Staff Report

To: Salt Lake City Planning Commission
From: Kelsey Lindquist, (801) 535-7930
Date: February 8, 2017
Re: PLNSUB2016-00914 & PLNSUB2017-0040

Planned Development and Minor Subdivision Plat

PROPERTY ADDRESS: 1008 South 1100 East
PARCEL ID: 16-08-406-014-0000 and 16-08-406-037-0000
MASTER PLAN: Central Community Master Plan
ZONING DISTRICT: R-1/5000 Single-Family Residential

3. Issue 3. Frontage of lots on a private street-Resolved

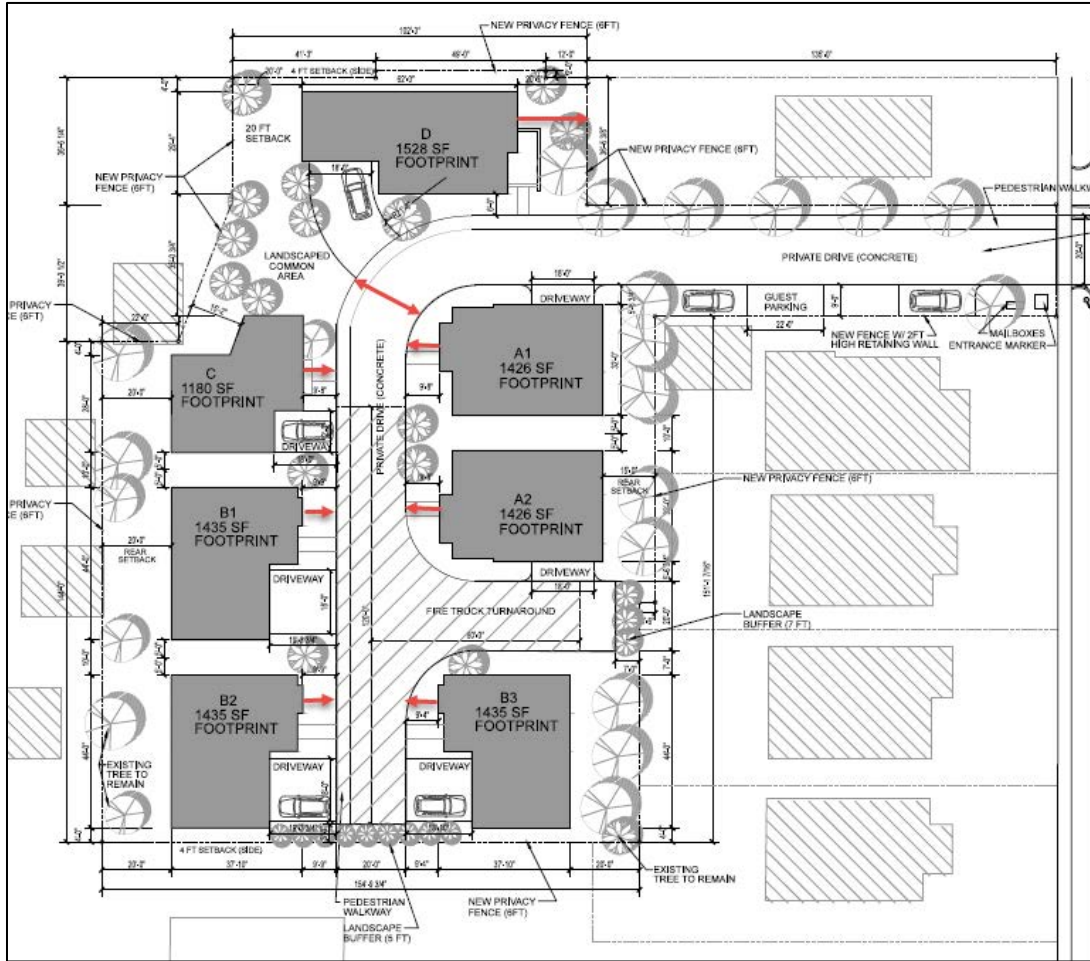
Each of the proposed seven lots will be accessed from a private drive, due to the nature of the interior lot. The private drive will be slightly reduced from the standard 30 foot requirement to 20 feet. The private drive will provide two way traffic for the development, in order to reduce any egress and ingress issues. Additionally, the private drive provides adequate access for fire trucks, in case of an emergency. The interior block lot is not typical for this neighborhood, the subject property is one of three located in the vicinity.

The Salt Lake City Zoning Ordinance in section 21A.36.010.C requires that “all lots front on a public street, unless specifically exempted from this requirement by other provisions of this title.” The intent of this regulation is to ensure orderly development that can be easily accessed and is visible from public streets. The lack of such regulation before zoning standards were adopted, allowed for haphazard development that was sometimes tucked away behind other properties and hidden from public view. These developments were often accessed on substandard private roads, which were difficult to access for emergency vehicles and were served by inadequate utility infrastructure. However, in some cases it is appropriate to modify this

street frontage standard through the Planned Development process if such a modification will result in a better development. The interior block redevelopment of the subject parcel is appropriate for this site.

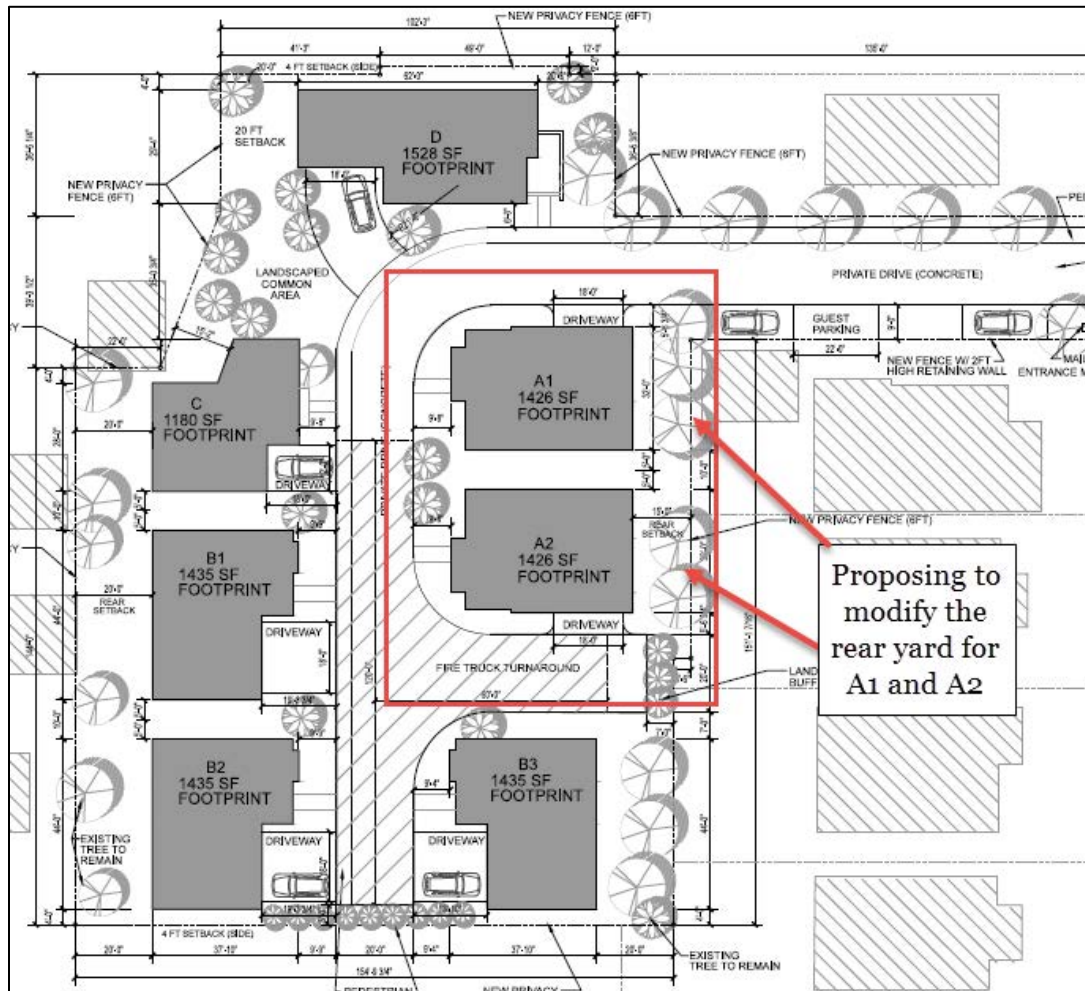
The proposal involves modifying the required rear yard for Lots 7 and 8. The R-1/5000 (Single-Family Residential) zoning district requires: twenty-five percent (25%) of the lot depth, or **twenty feet (20’), whichever is less**. The setbacks for the structures on lots 7 and 8 are proposed to be modified from the required **eighteen feet (18’)**, which is based on the lot depth for lots 7 and 8, to **fifteen feet (15’)**. The existing multi-unit structure is approximately **twelve feet (12’)** from the eastern property line and adjusts to approximately 7 feet at its southern edge. The existing structure is located significantly closer to the abutting properties to the east; however, the structure is only one story in height. The proposed structures A1 and A2 will reach **twenty-six feet (26’)** in height with a wall height of **twenty feet (20’)**. While these proposed heights are permitted, they are substantially higher than the existing structures.

To mitigate the potential impacts created by A1 and A2 on Lots 7 and 8, the full eighteen feet (18’) should be provided for the rear yard. The addition of three feet (3’) **would provide additional** buffering for the abutting properties to the east and would limit the potential of impact on these particular properties. The other proposed lots within the development are more than meeting the required rear yard setback by providing 20 feet.

Condition: The rear yards for Lot 7 and 8 meet the required rear yard for the R-1/5000 Zoning District

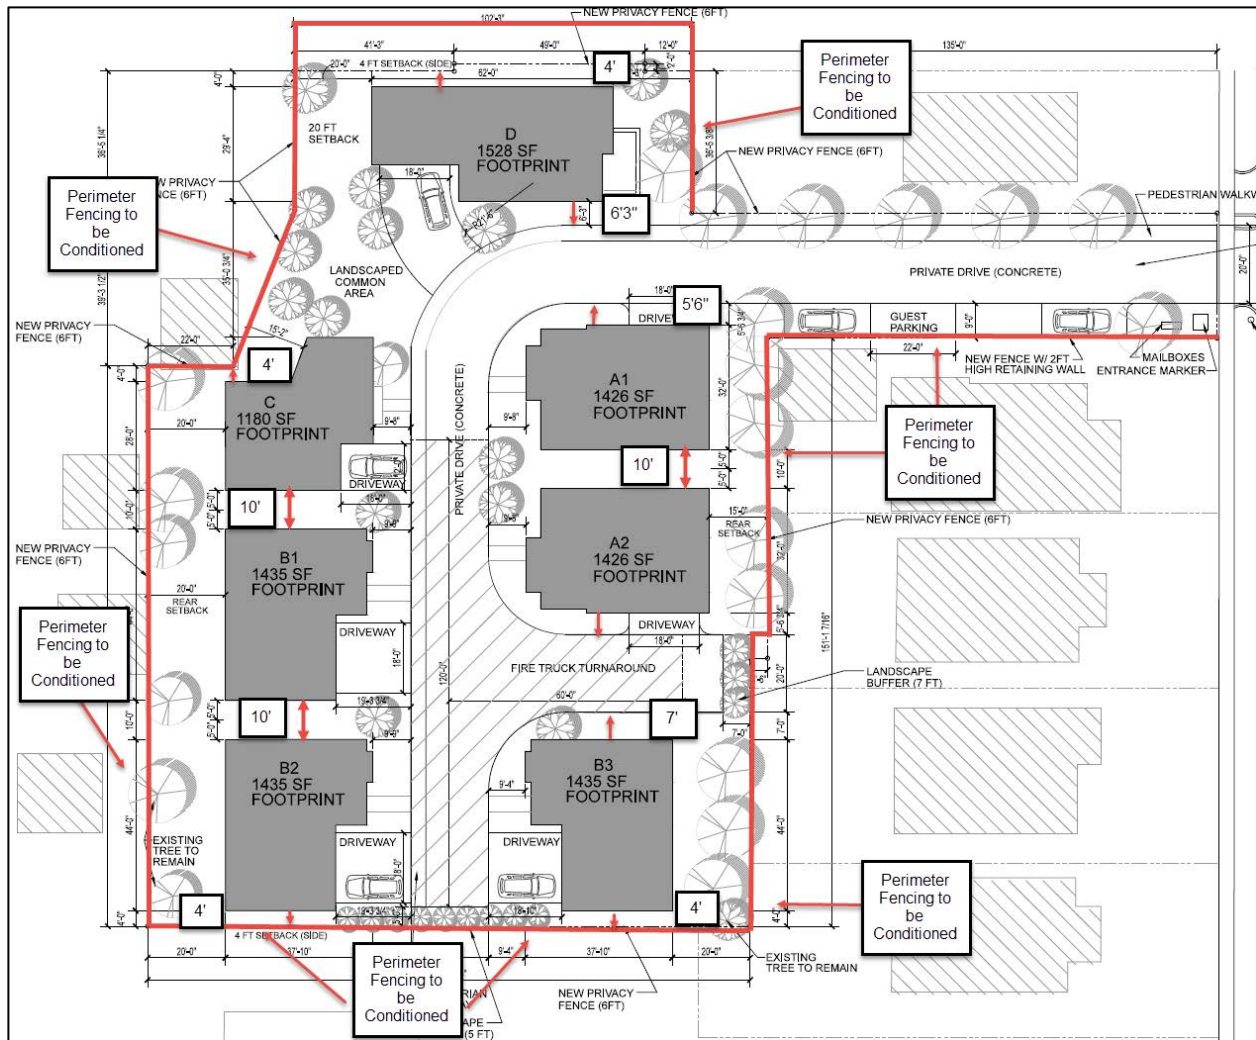
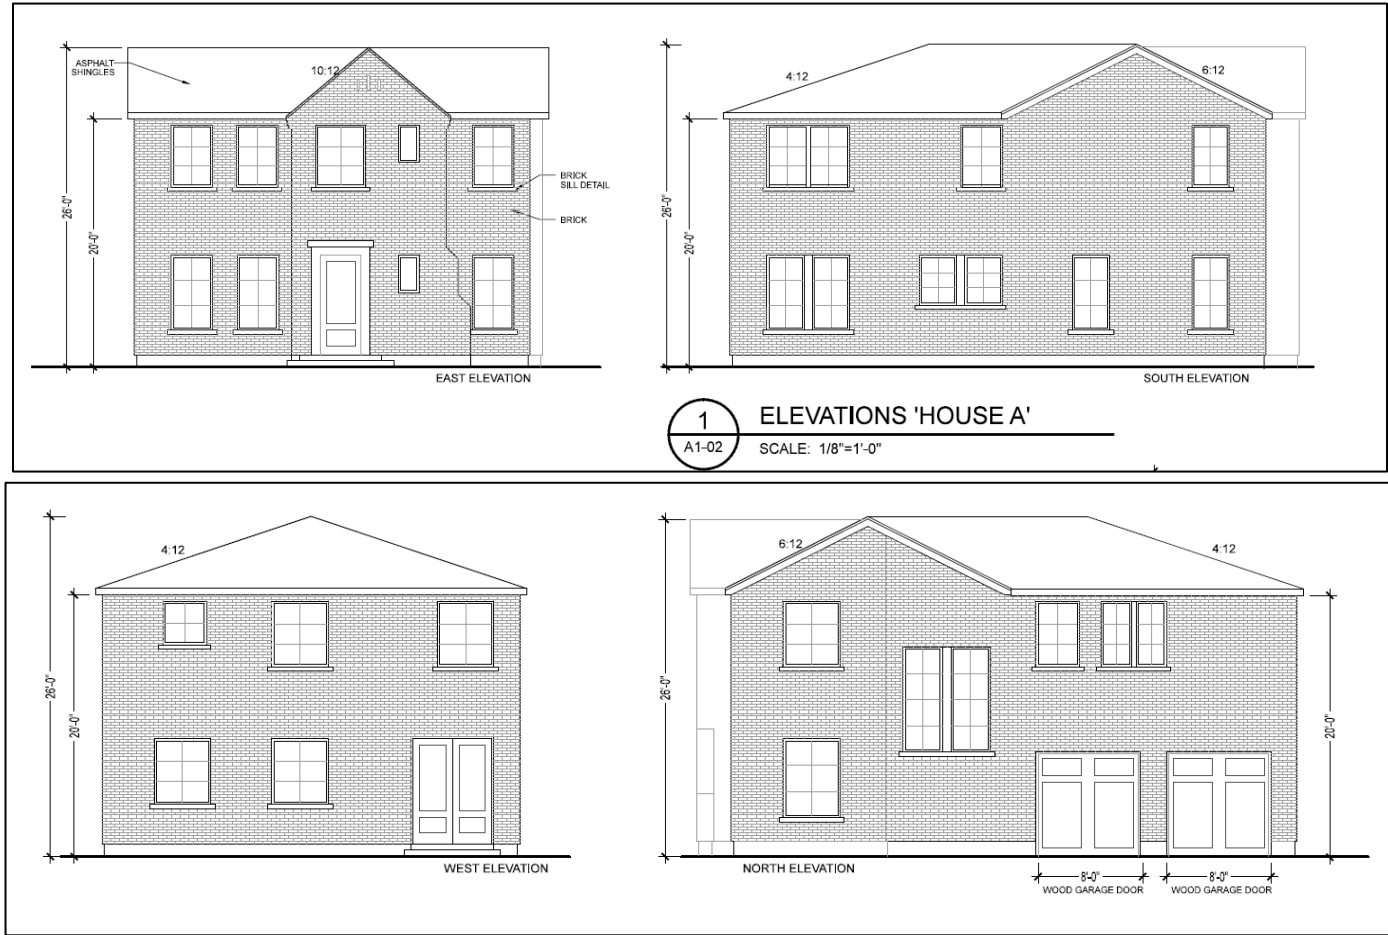
The development proposes that the interior side yard setbacks be modified to the setbacks specified on the attached site plan (Attachment B). The modified side yard setbacks for each proposed structure, does reduce the overall open space within the development. The two properties to the north have rear yards that will abut Lot 1 (Structure D). The abutting property 992 South 1100 East is approximately 204 feet in depth, which will abut the interior side yard of Lot 1. The rear yard of the property to the west, 993 South McClelland, will also abut a portion of the rear yard for Lot 1. A small portion of the northern interior side yard for Lot 2 will abut the rear yard of 1003 S. McClelland. The southern property line abuts another interior block lot, 1028 S. 1100 E. **Lot 5 and Lot 6 are proposing four foot (4') setbacks for the interior side yards.** The property that abuts Lot 5 and 6 is setback approximately seventeen feet (17') from the property line. The arrows in the image below, illustrate the properties that are abutting an interior side yard of the proposed development.

The lack of the full required interior side yards between each structure will push the proposed structures slightly closer together, please refer to the illustration below to see the requested side yard modifications. Overall, each proposed lot is modifying the interior side yard requirements by three feet (3') to five feet (5') in size. The side yard modifications are strictly within this development and will not impact the abutting properties, due to adequate buffering and landscaping. Referring to Attachment B and the illustration below, the reduction is not uncharacteristic of the existing development pattern within the neighborhood.

The proposed interior side yards are compatible for the development and the neighborhood, however due to the potential to impact abutting properties, the applicant shall provide a perimeter fence and landscaping to adequately screen and buffer the development. The illustration below, highlights the abutting yards that will be screened via fencing and landscaping. The condition associated with this issue is to require the proposed perimeter fencing. Please refer to issue 8 for the discussion and condition of landscaping.

Condition: The proposed perimeter fence is required.

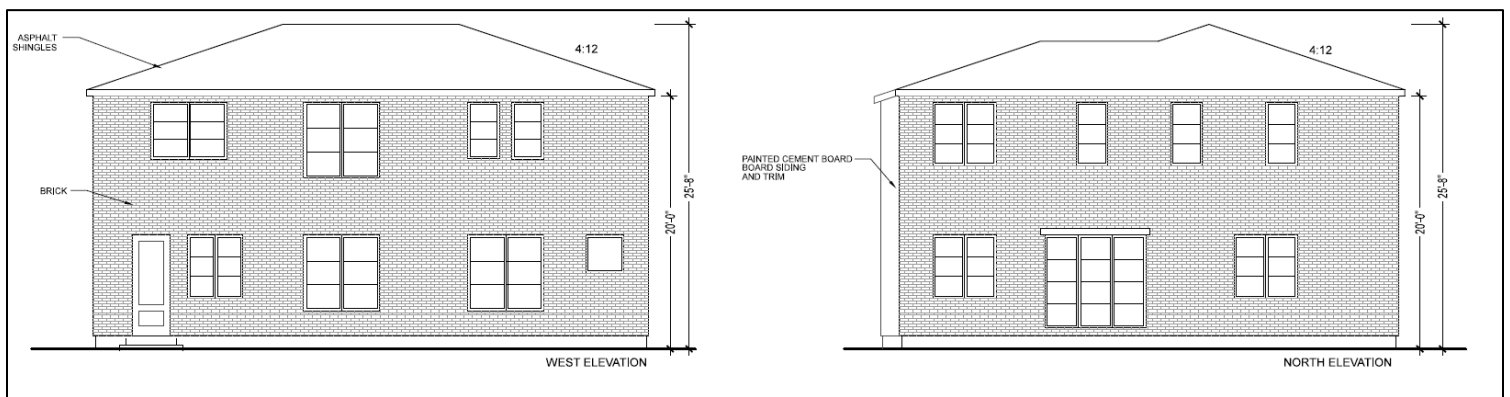
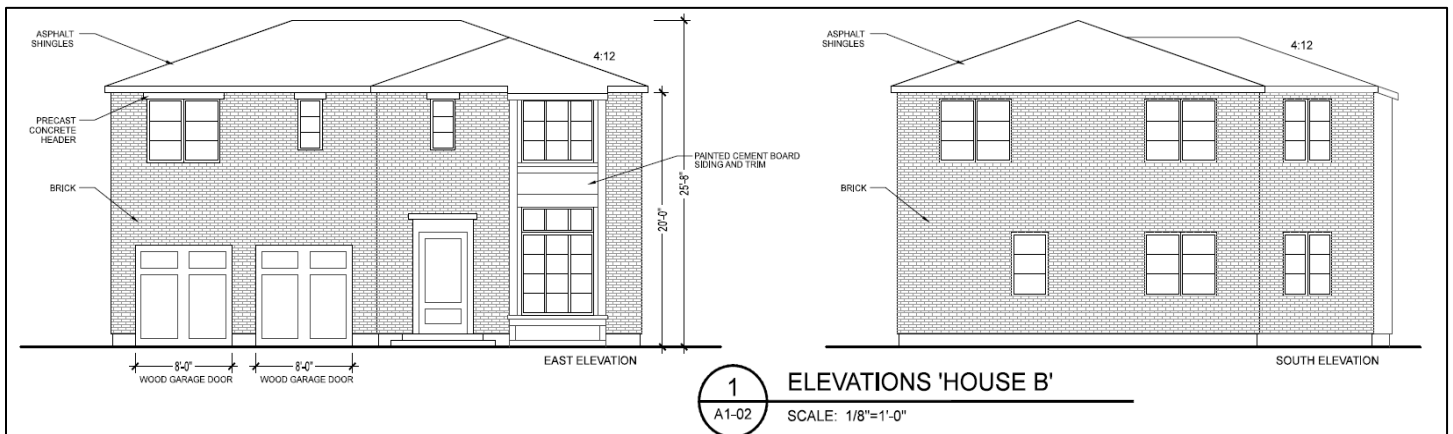
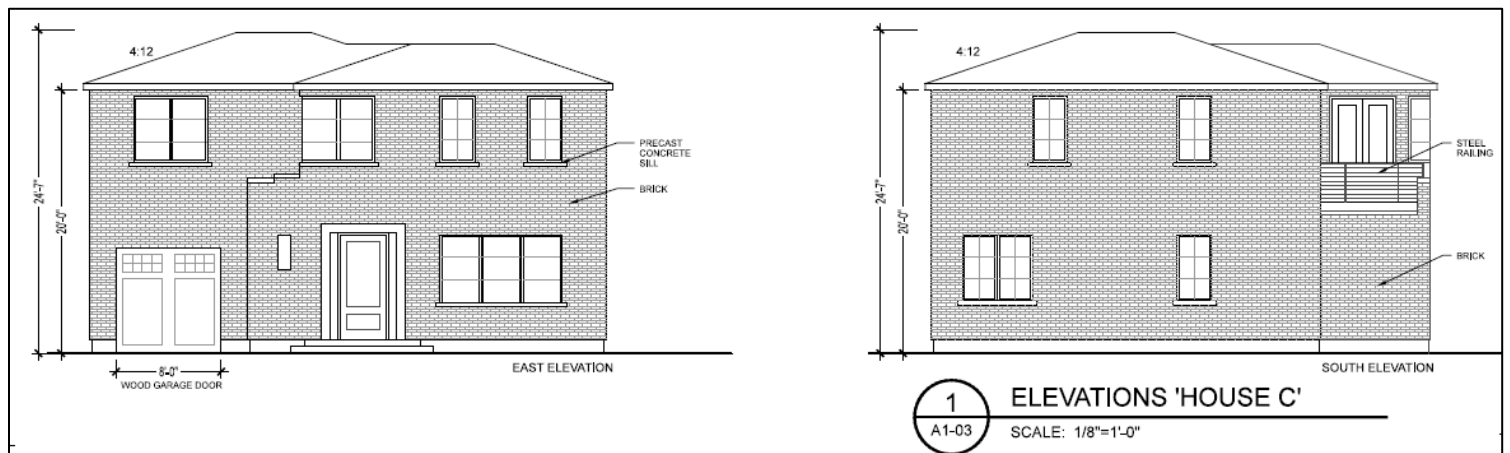
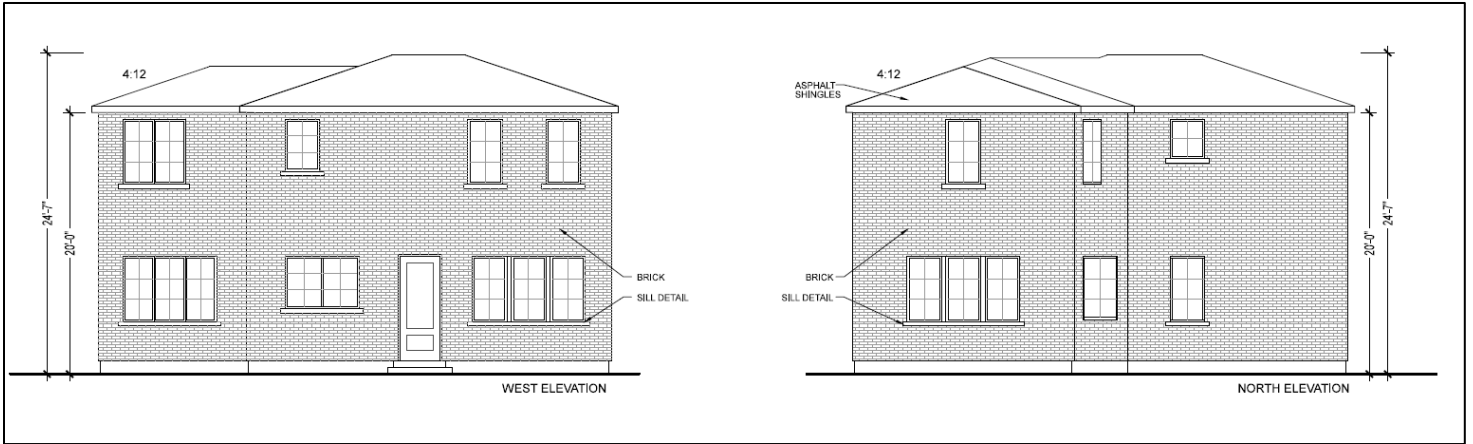
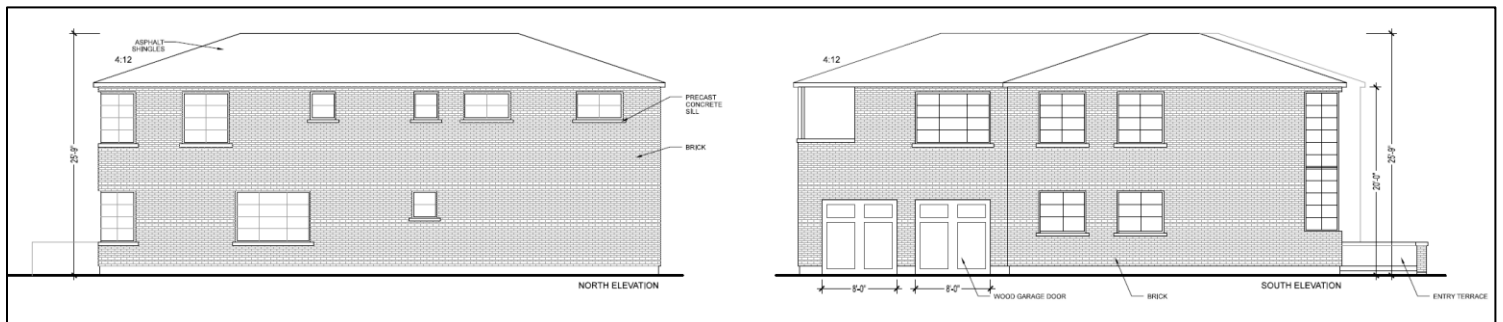
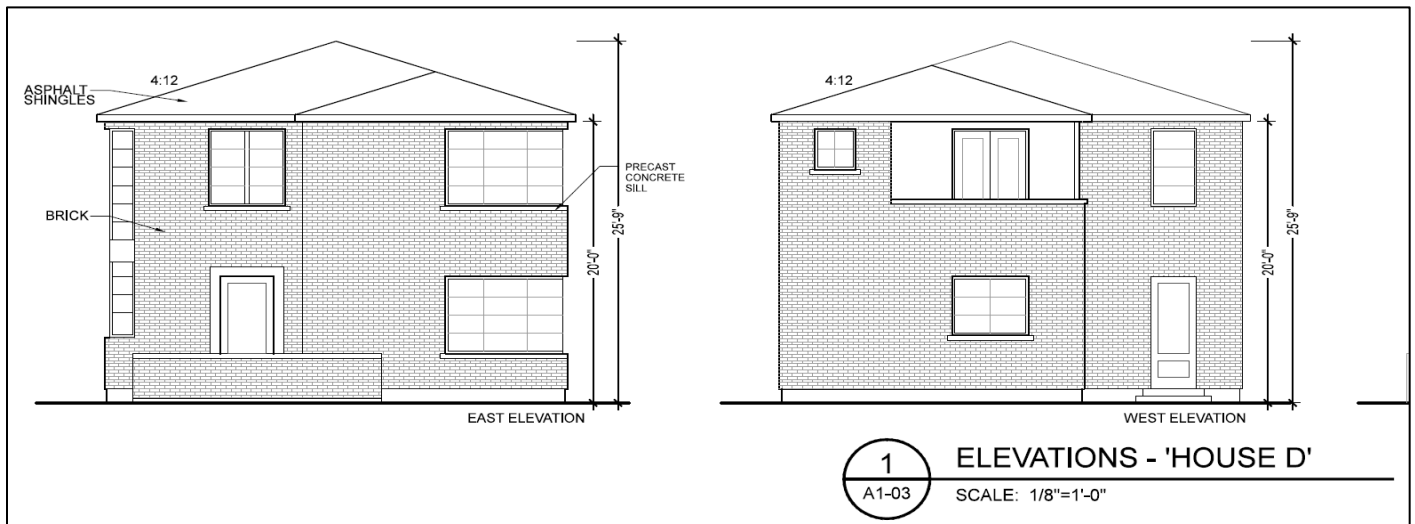
The planned development involves constructing 7 new single-family structures, which range in height from twenty-six feet (26') for 'House A', twenty-five feet eight inches (25'8") in height for 'House B', twenty-four feet seven inches (24'7") for 'House C', and twenty-five feet nine inches (25'9") for House D. Each proposed structure is meeting the required twenty foot (20') wall height maximum, and all are proposing a roof pitch of 4:12. 'House A' has additional rooflines at a steeper pitch, please reference the illustrations below and Attachment C.

The lowered height, in conjunction with requiring the applicant to provide adequate rear yard setbacks, will aid in mitigating any potential impact caused by the wall height. Additionally, the western portion of the property sits higher than the properties facing McClelland. The grade difference between the properties will be mitigated by the lower proposed heights, the provided rear yards and the proposed landscaping. The image below, illustrates the proposed elevations for the development.
